7103893
B133 RENOVATIONS (FRCE)

MCAS Cherry Point, NC
AMENDMENT #0003

This amendment is being issued to respond to pre-award RFIs and provide updated drawing.

MECHANICAL DETAILS

M-504

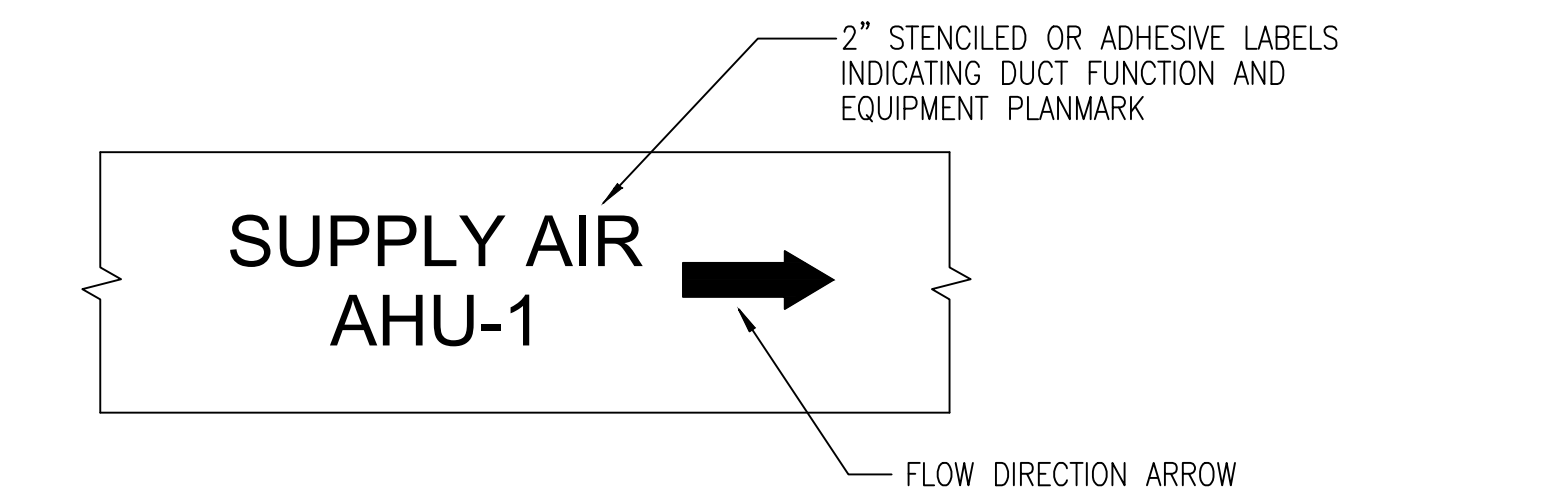
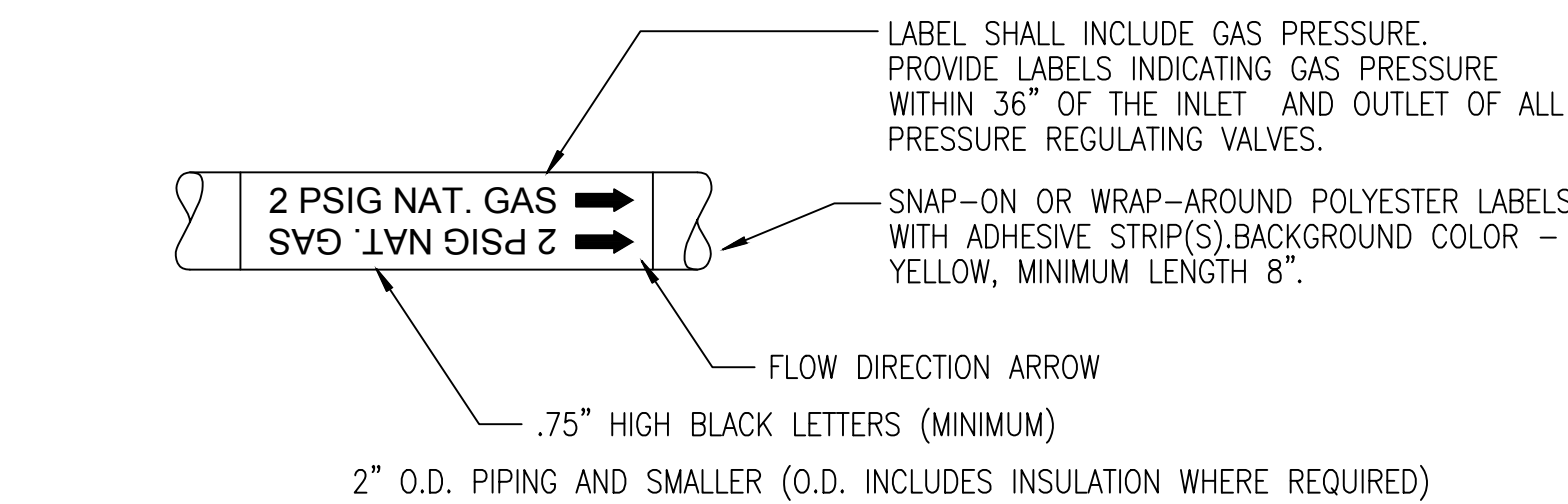
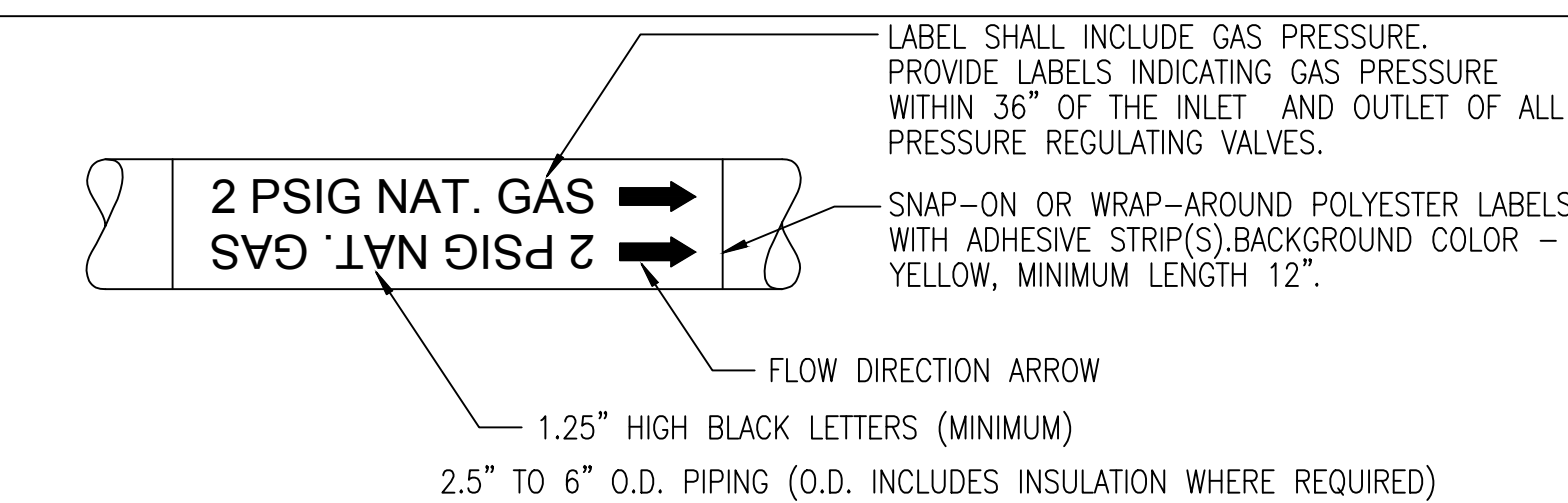
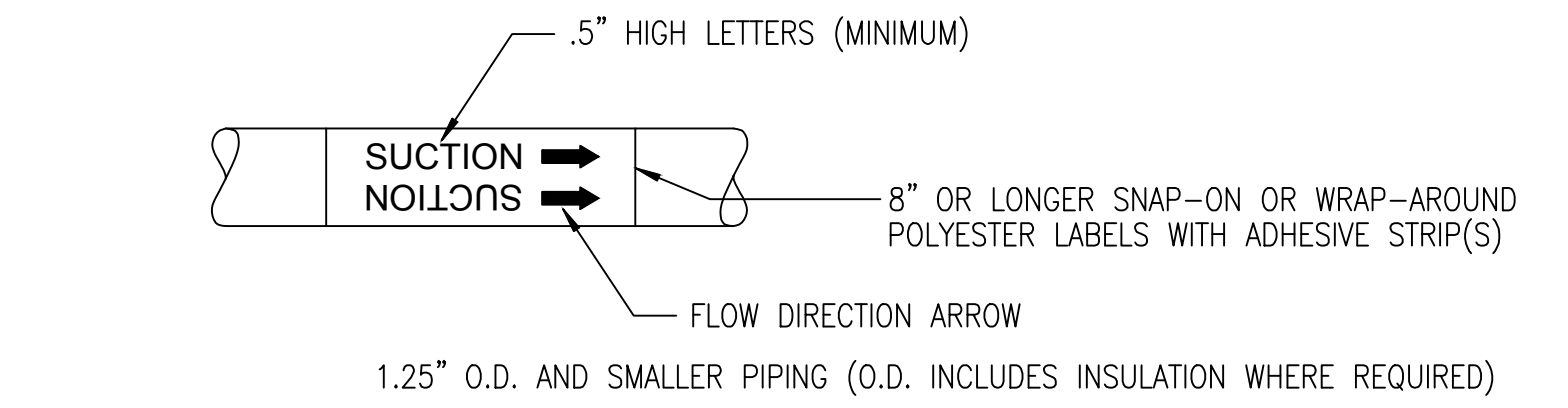
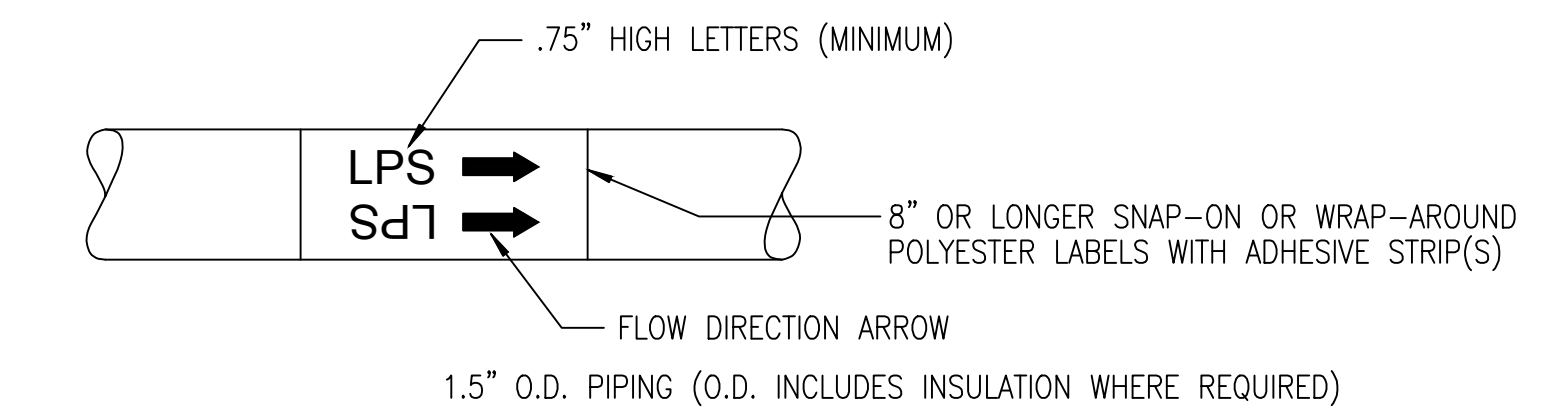
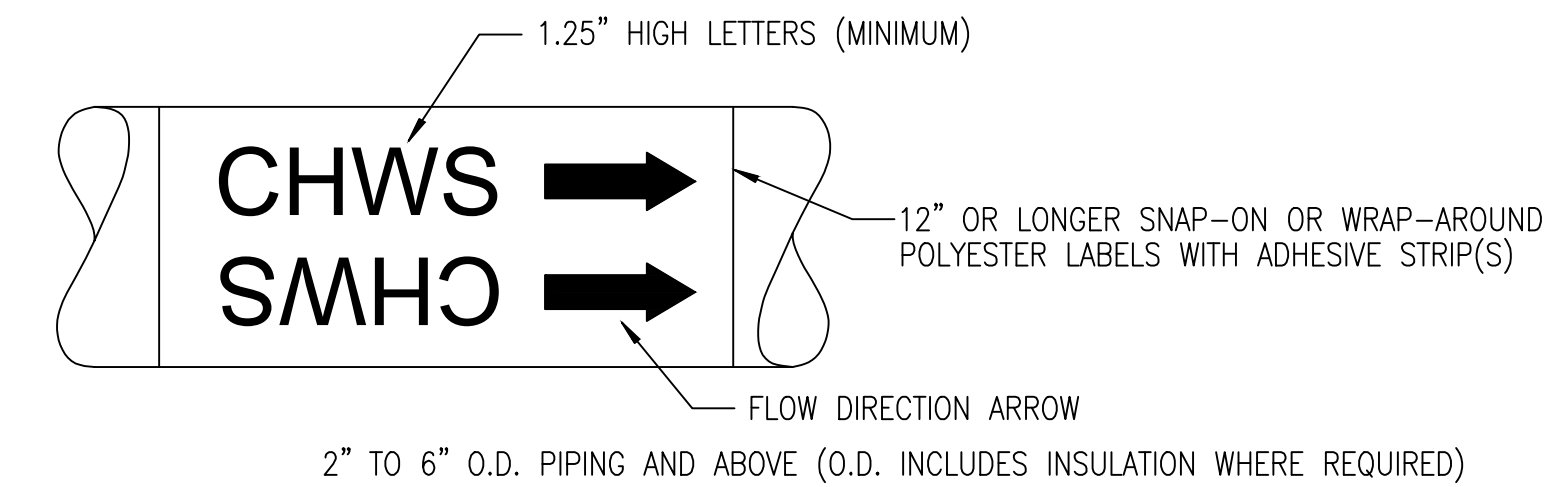
5. In Appendix D of Spec Section 23.05.93, the equipment listed in the table is not the same equipment that is on the schedule on page M-601. Because of this, it is unclear what water gauge is to be used for the ductwork systems. Please, clarify.

DUCTWORK CLARIFICATIONS

Submit Proposals in accordance with RFP, Specifications, Drawings, and all Amendments. See revised drawing sheet M-504 with revision #1 "DUCTWORK CLARIFICATIONS", 21 April 2021. The "Duct Construction Classification" table on sheet M-504 is to be used for determining the pressure classification for each duct system. Please note that for B133, the classification shown for "AHU-1" on sheet M-504 is to be used for the rooftop units (RTU-1, -2, -3).

RTU-1,2,3	-	ALL EF'S
SUPPLY AIR FROM AHU TO TERMINAL BOXES/GRILLES	3"	-	-
SUPPLY AIR FROM TERMINAL BOX TO GRILLE/DIFFUSER	2"	-	-
RETURN AIR MAIN TRUNK LINES	2"	-	-
RETURN AIR RUN-OUTS FROM TRUNK TO GRILLE/DIFFUSER	1"	-	-
RELIEF AIR	1"	-	-
OUTSIDE AIR	1"	-	-
EXHAUST MAIN TRUNKS	1"	-	1"
EXHAUST RUN-OUTS FROM TRUNK TO GRILLE/DIFFUSER	1"	-	1"

- * ALL DUCT SHALL BE SEAL CLASS "A", PER UFC 3-410-01.
- * ALL 1" PRESSURE CLASS SUPPLY/RETURN/EXHAUST/RELIEF/OUTSIDE AIR SHALL BE LEAKAGE CLASS 24.
- * ALL 2" PRESSURE CLASS SUPPLY AIR SHALL BE LEAKAGE CLASS 12.
- * ALL 2" PRESSURE CLASS RETURN AIR SHALL BE LEAKAGE CLASS 24.
- * ALL 3" PRESSURE CLASS SUPPLY AIR SHALL BE LEAKAGE CLASS 6.
- * ALL DUCTWORK SHALL BE DALI TESTED PER SPECIFICATIONS.
